**PLANNING COMMISSION AGENDA
JUNE 15, 2023 – 6:30 P.M.**

Planned Unit Development - Hubbell Development Services, Inc. – Lots 1-3 Mayfair 2nd Addition Replat Seven and Lot 2 Mayfair 2nd Addition Replat Three

**CITY OF LA VISTA
PLANNING DIVISION
RECOMMENDATION REPORT**

Exhibit A – Sidewalk Additions

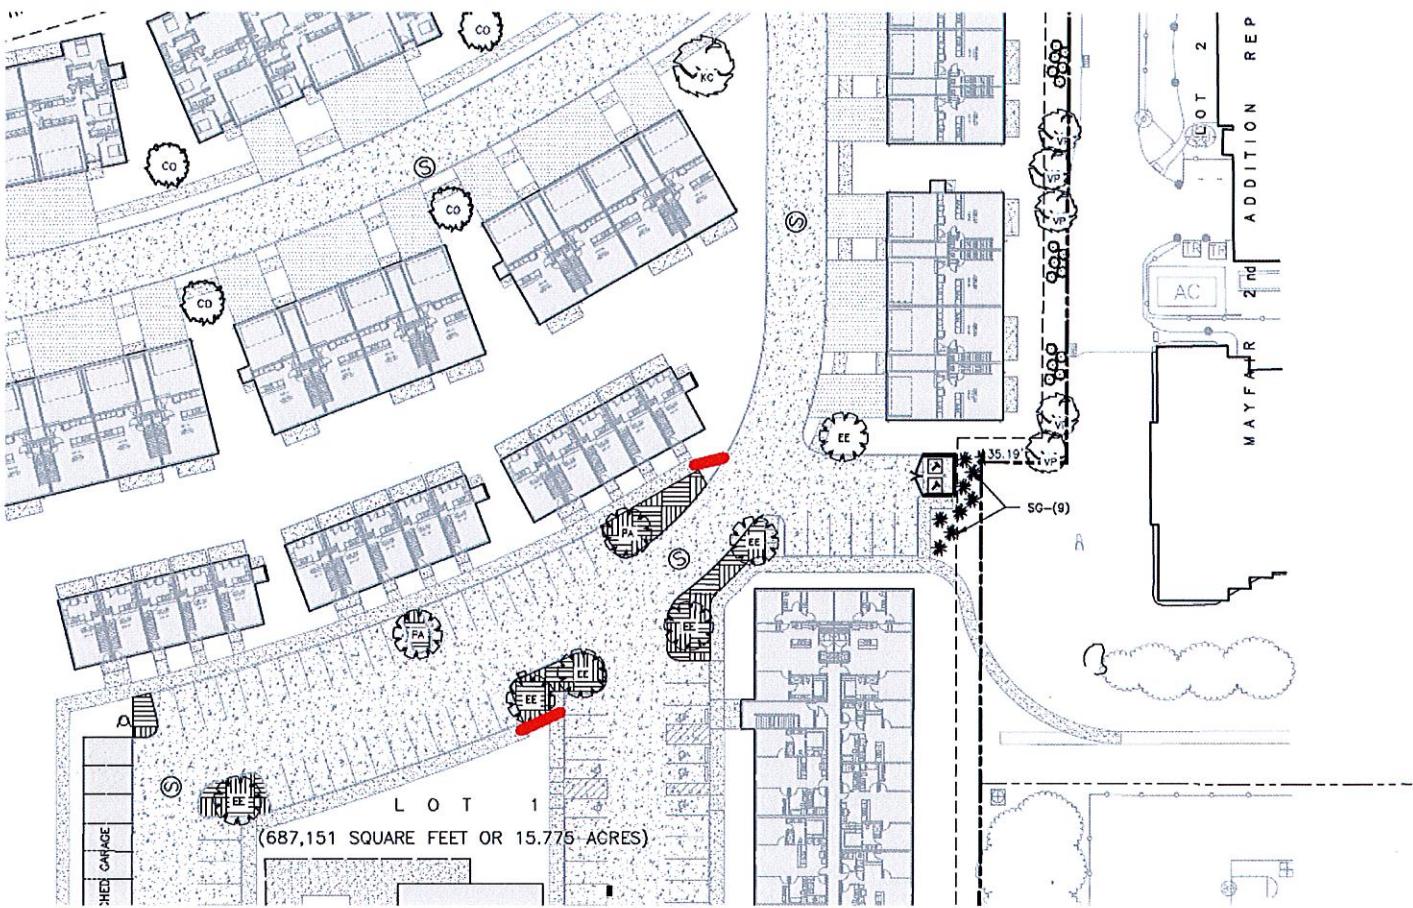
6. Zoning Ordinance Section 5.15.04.07 and 5.15.04.16 – To complete the sidewalk network in the development to provide adequate pedestrian connectivity, please update the plan to include the two sidewalk connections noted in red on the plan in Exhibit A, attached to this letter.

Sidewalks have been added per Exhibit A.

FIGURE 2 Site Plan

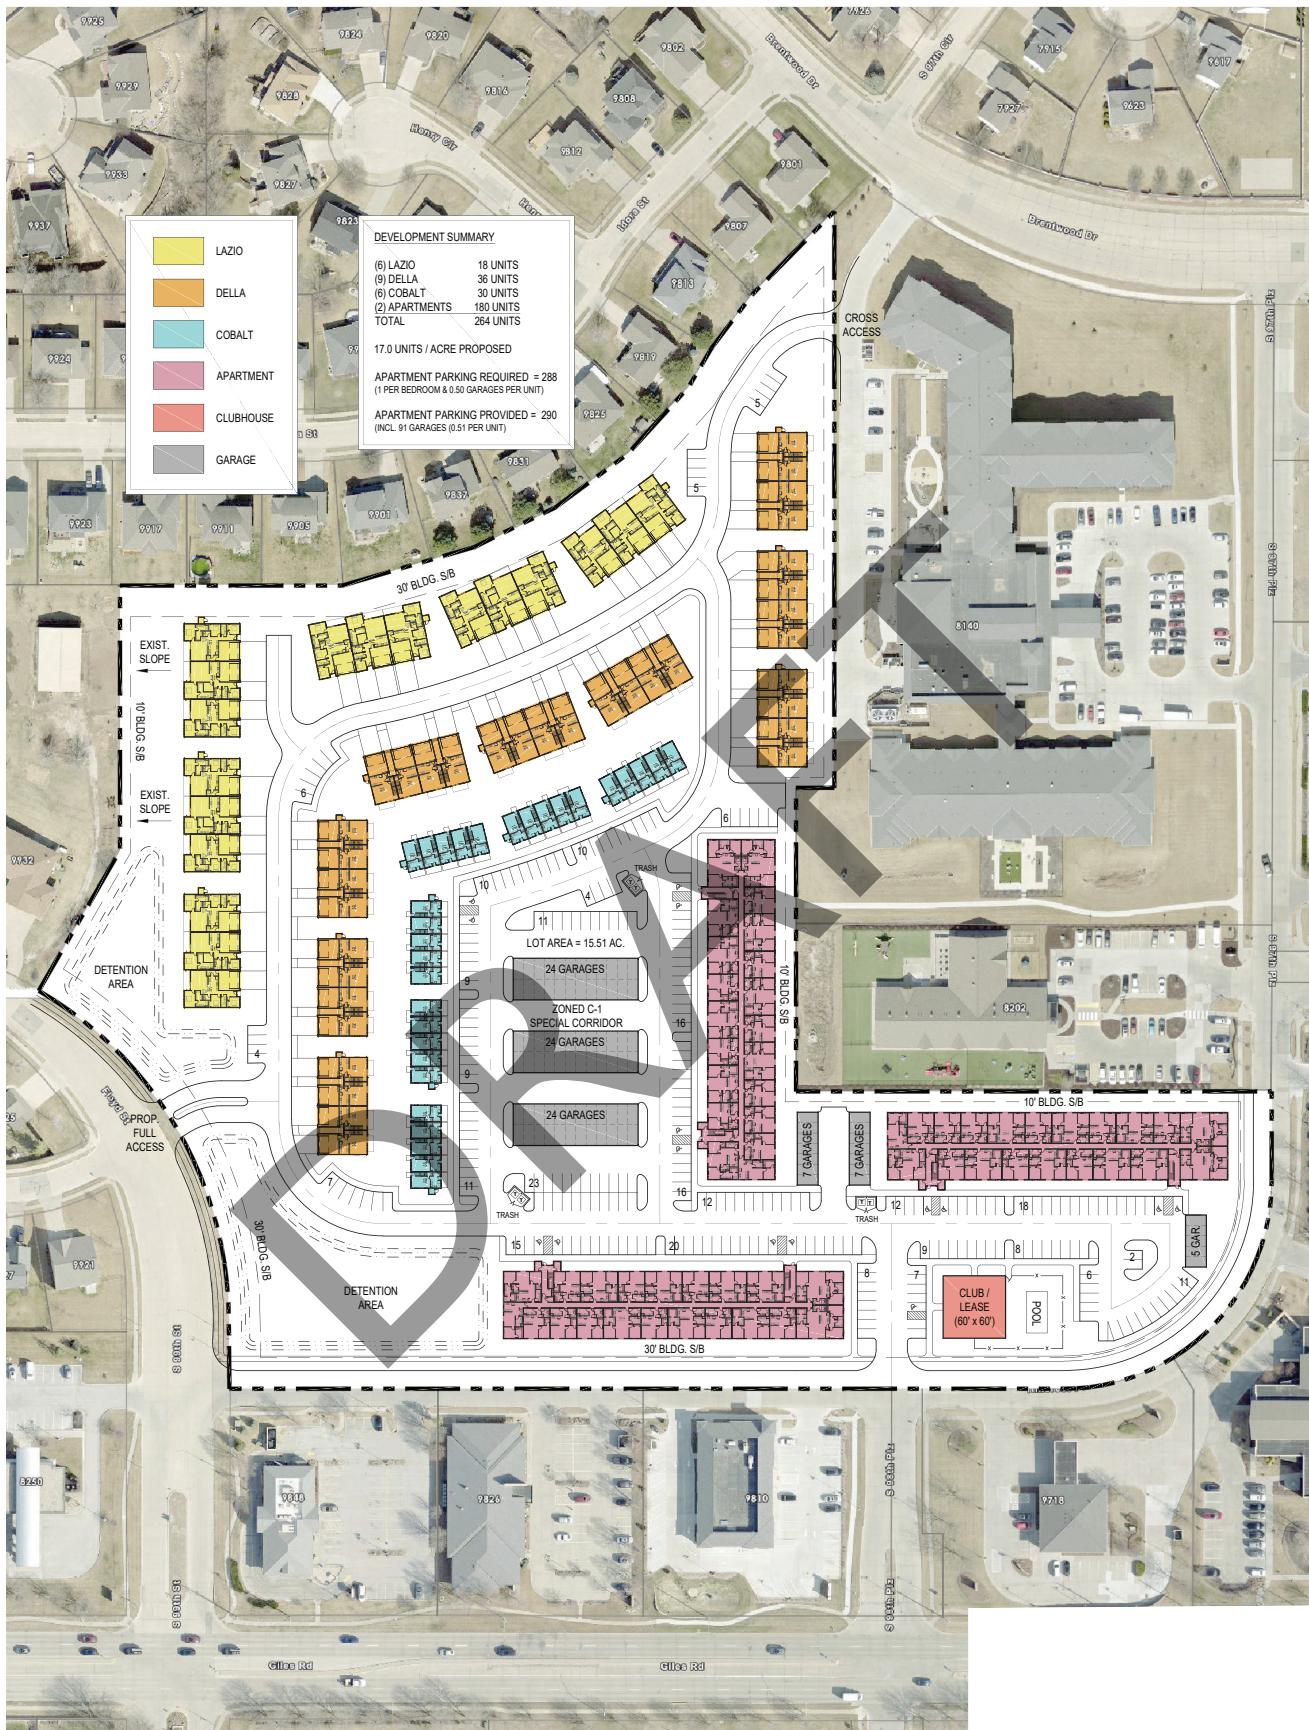
Based on the site plan provide in Figure 2 and the associated development summary table, the number of apartment units listed (2 – 180 units) does not match the number of apartment buildings shown in the site plan (3). **It should be determined if this is a simple labeling error, or if there are additional dwelling units unaccounted for. Note: It appears there are 20 units per floor. If each building has 3 floors, the total dwelling units would be 180.**

- Based on the site plan provide in Figure 2 and the associated development summary table, the number of apartment units listed (2 – 180 units) does not match the number of apartment buildings shown in the site plan (3). *Note: It appears there are 20 units per floor. If each building has 3 floors, the total dwelling units would be 180*
- Trip generation rates are consistent with ITE's Trip Generation Handbook and the proposed site characteristics.

FIGURE 6B
Future (2044) Right-In Right-Out (RIRO) at S. 98th Plaza
Traffic Conditions

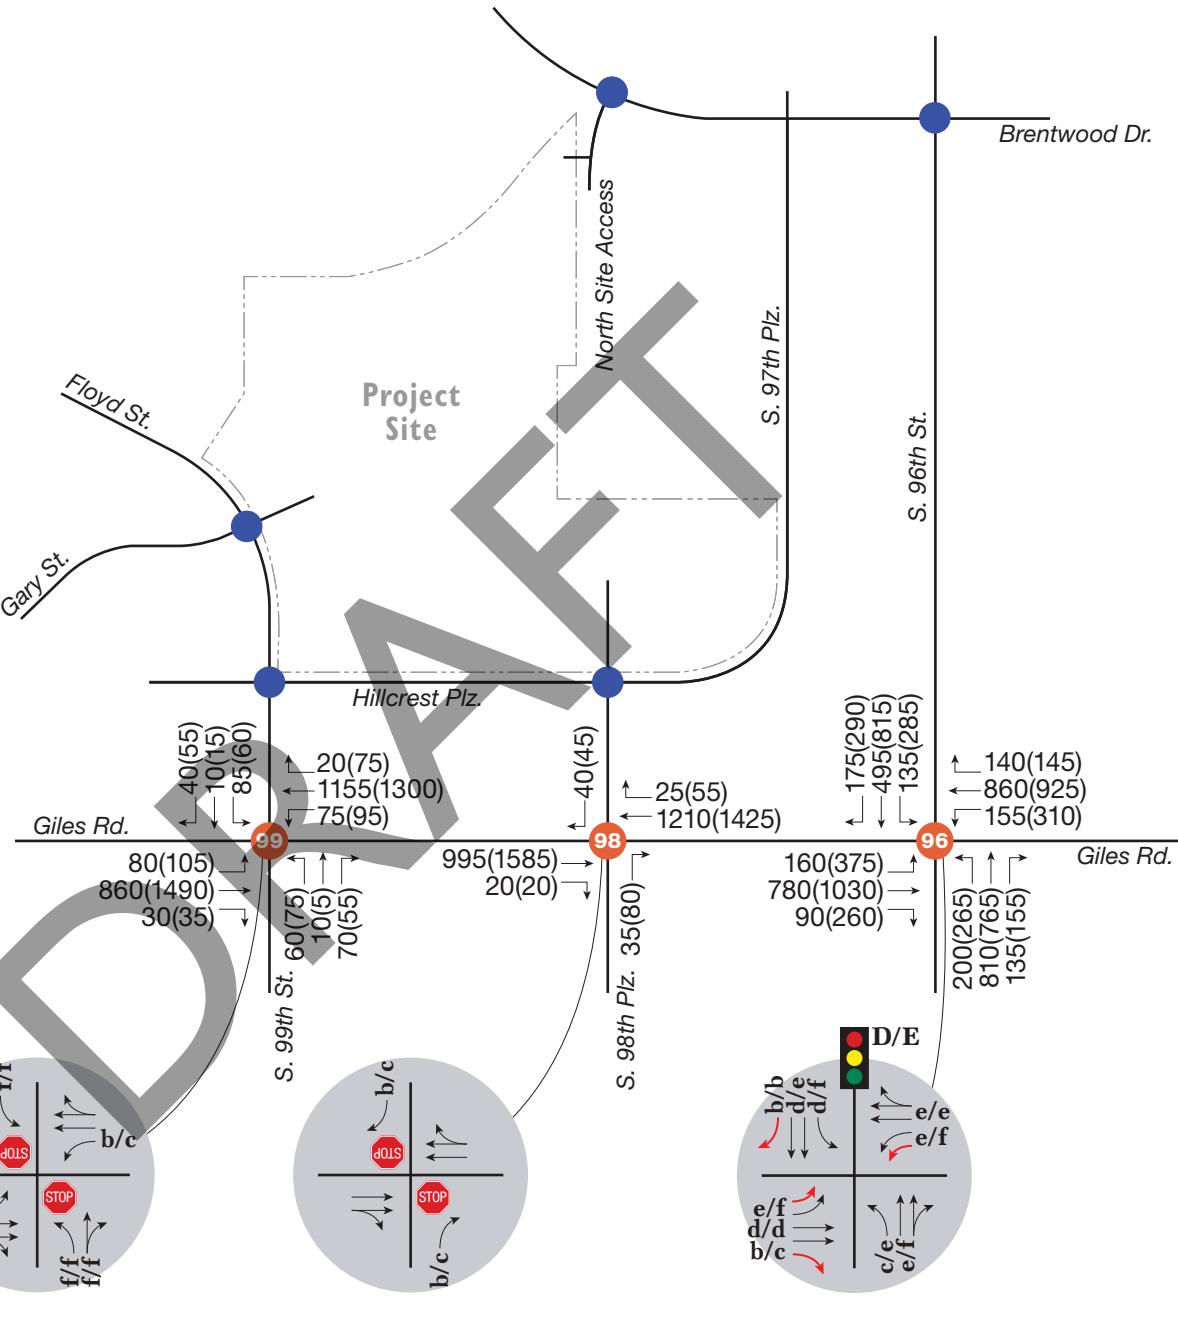
*****NOTE: Recommendations in the summary text and Figure 6B, which summarizes improvements for 98th Street & Giles Road as RIRO, do not match. The bullets above***

correspond to Figure 6B of the report, while the recommendations text note minimum storage requirements for a WB right-turn lane and addition of a NB dual left-turn lane.

- Recommendations for 96th Street & Giles Road in the summary text and Figure 6B, which summarizes improvements for 98th Street & Giles Road as RIRO, do not match. Figure 6B illustrates improvements that match text earlier in the TIA but are different than what is listed in the recommendations section.
